AMENDMENTS TO THE DRAWINGS

REMARKS

Benjamin et al.
Serial No. 10/697,695

Fig.1

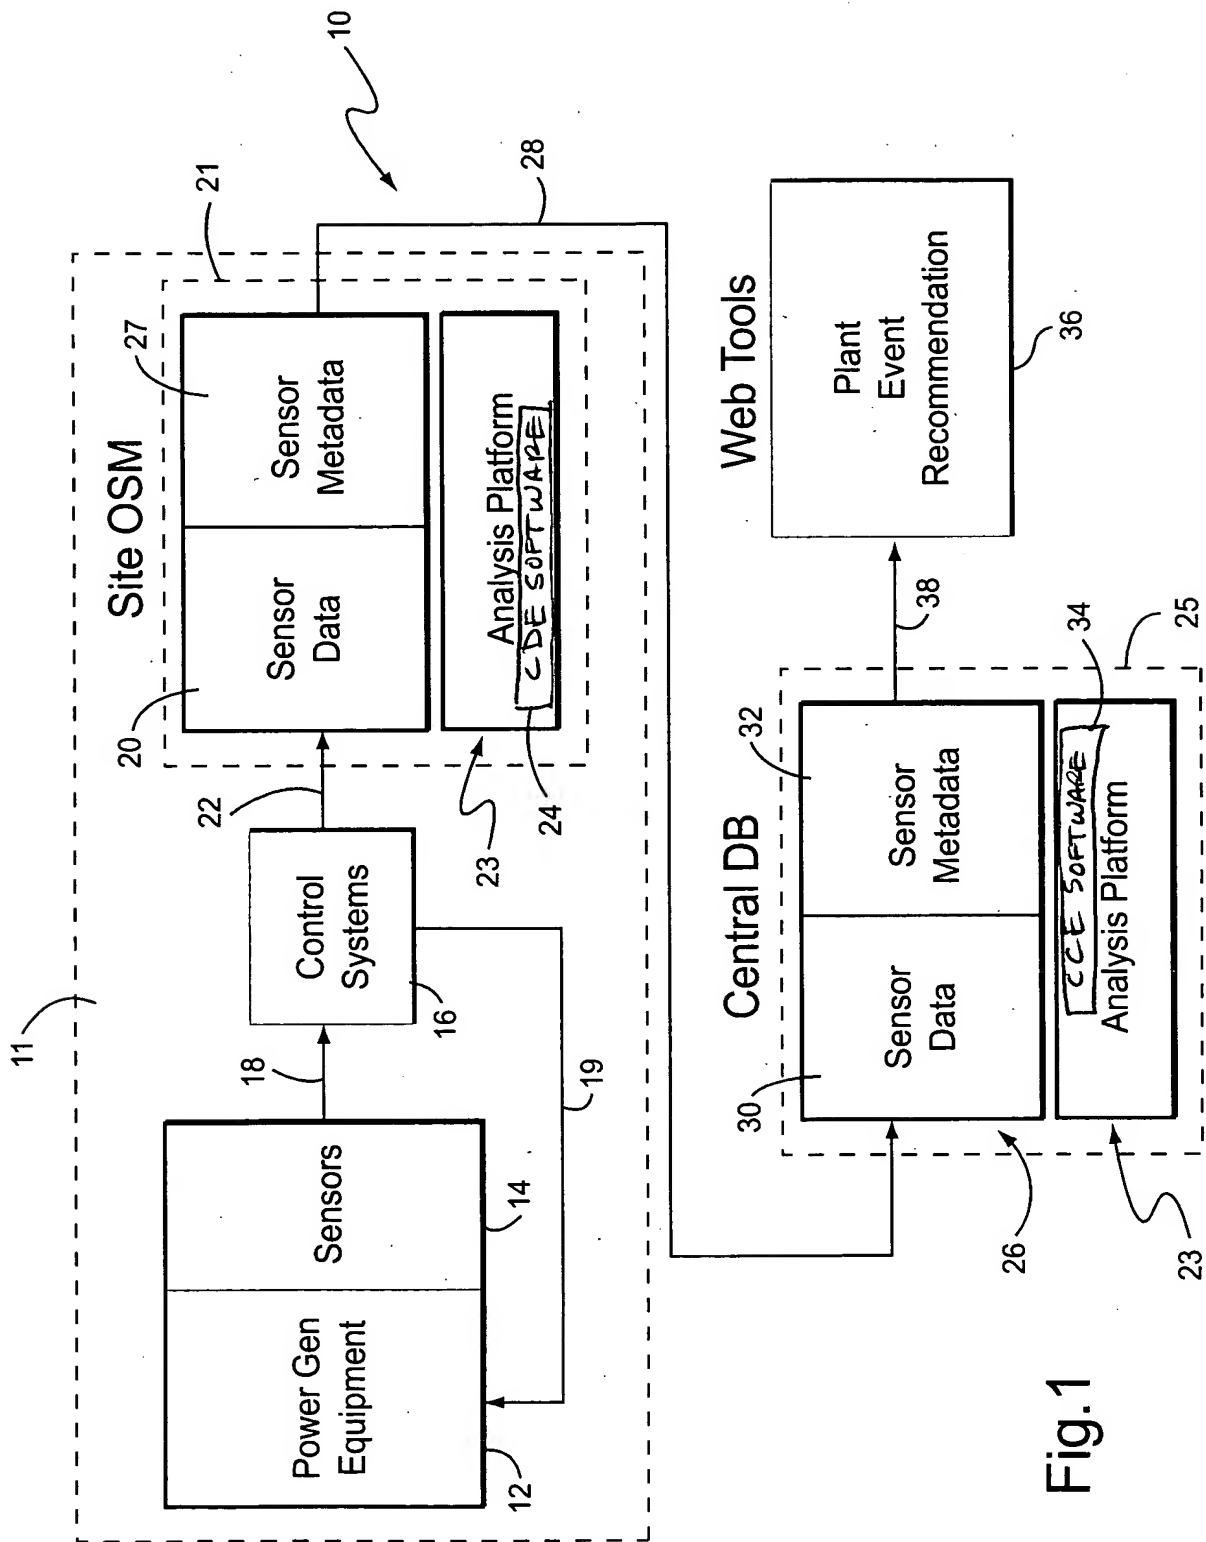
The attached sheet of drawings includes changes to Fig. 1. This sheet replaces the original sheet including Fig. 1. In Fig. 1, the portion of analysis platform 23 in on-site monitor 21 has been amended to specifically show the CDE software 24, and the portion of analysis platform 23 in central management system 25 has been amended to specifically show CCE software 34.

In the outstanding Office Action of February 11, 2005, the Examiner objected to the drawings and suggested that Figure 1 be amended so that reference numeral “24” and “34” identify a component inside the “Analysis Platform” illustrating the “CDE Software” and the “CCE Software”, respectively. The amendment to Figure 1 proposed by the Examiner has now been made. Accordingly, the Examiner’s objection to the drawings should be withdrawn.
